SUB14-00005: Stonehaven Subdivision / Iron Mountain Real Estate

STONEHAVEN SUBDIVISION

RE: SUB14-00005 / Stonehaven Subdivision, Preliminary and Final Plat

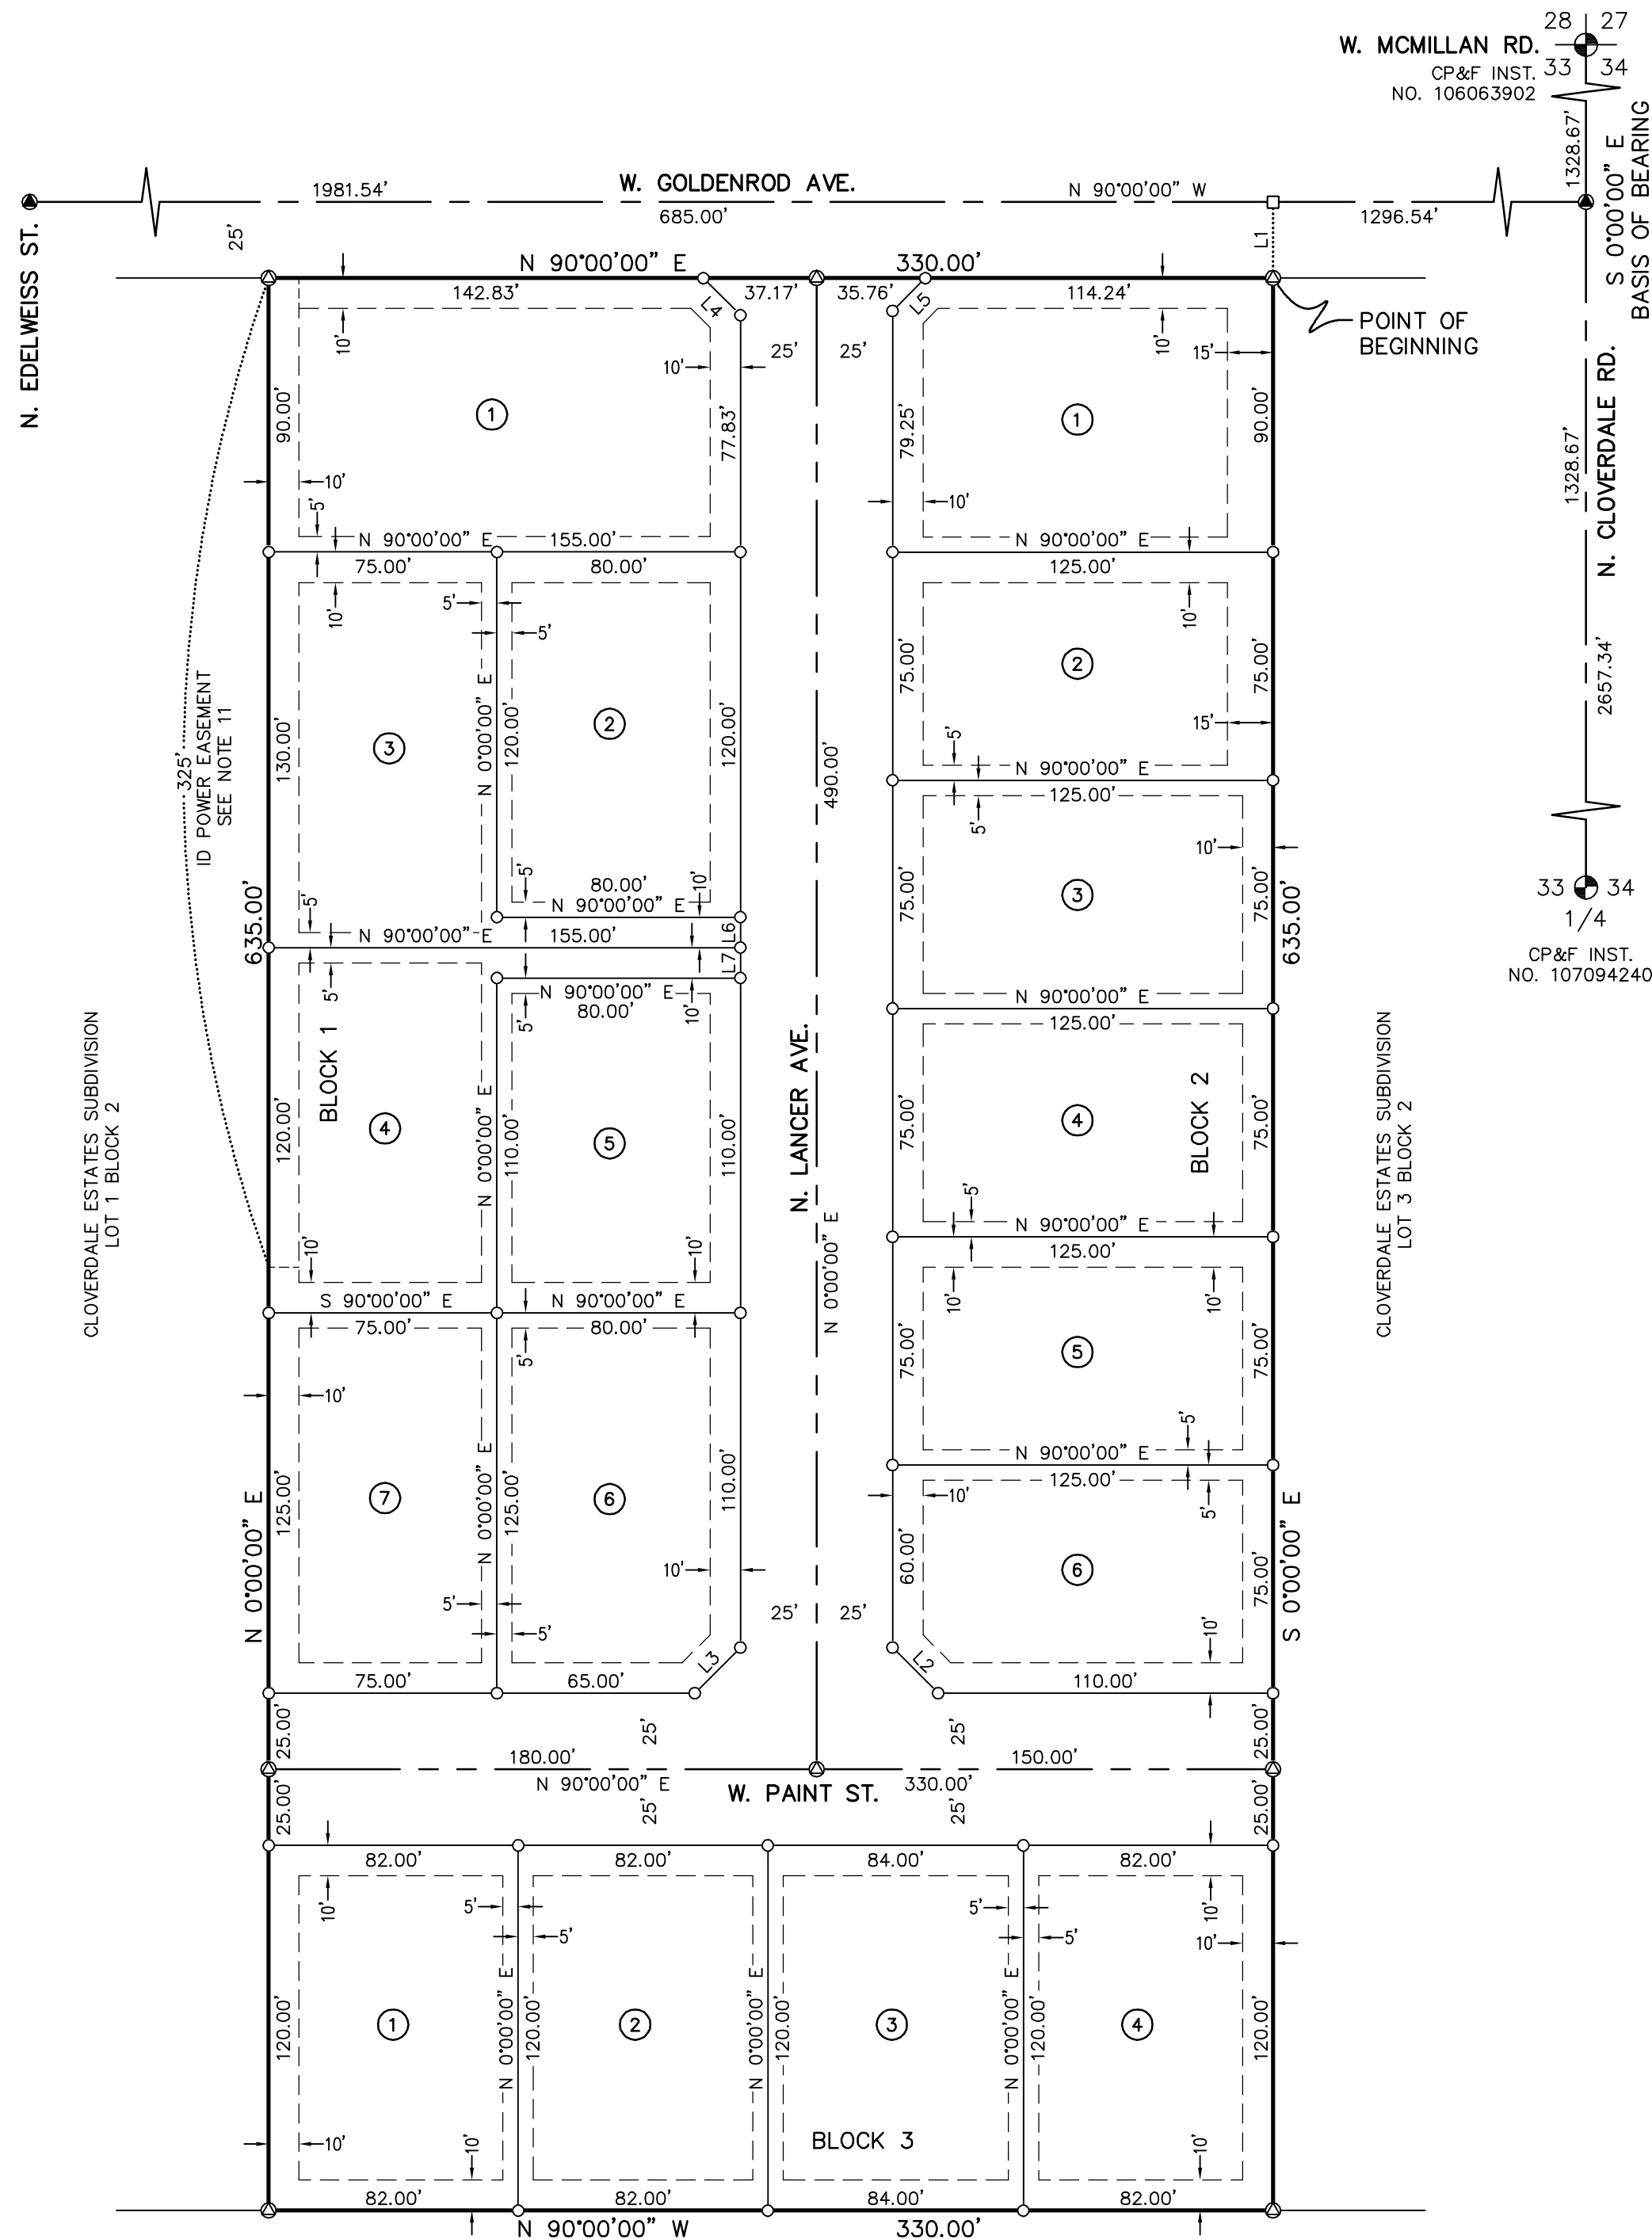
1. Prior to approval by the City Council the Final Plat shall include delineations that describe the boundaries of the perpetual ingress/egress common driveway easement for Lots 2-5.

- B. Plat Note Requirements:
 - 1) A plat note shall state: "*Vehicular access to Lots 2-5, Block 1 shall be provided from a common driveway and not from Lancer Avenue.*"
 - 2) A plat note shall set forth the legal description of the driveway(s) and conveys to those lot owners taking access from the driveway(s) and easement(s), the perpetual right of ingress and egress over the described driveway(s), and provides that such perpetual easement(s) shall run with the land.

- 2. Any change to the existing irrigation ditch must be approved with a License Agreement with the Nampa & Meridian Irrigation District. If the existing irrigation easement is changed, the new easement location and dimension shall be designated on the Final Plat.

- 4. A plat note shall state: "Vehicular access to Lot 1, Block 1 and Lot 1, Block 2 shall be provided from Lancer Avenue, not from Goldenrod Avenue."

6. Lot 1, Block 1 and Lot 1, Block 2 must provide a minimum 20 foot wide landscape buffer easement next to West Goldenrod Avenue. A landscape plan shall be prepared by a licensed landscape architect. The landscaping shall be installed or bonded for prior to the signature of the Boise City Engineer.
7. The lot lines shall be adjusted so that all lots meet the R-1B dimensional standards found in Section 11-04-03.
8. The landscape buffer easement shall be shown on the Final Plat with a plat note stating:
“Lot 1, Block 1 and Lot 1, Block 2 are subject to a 20 foot wide landscape easement to be maintained by the Stonehaven Homeowner’s Association.”
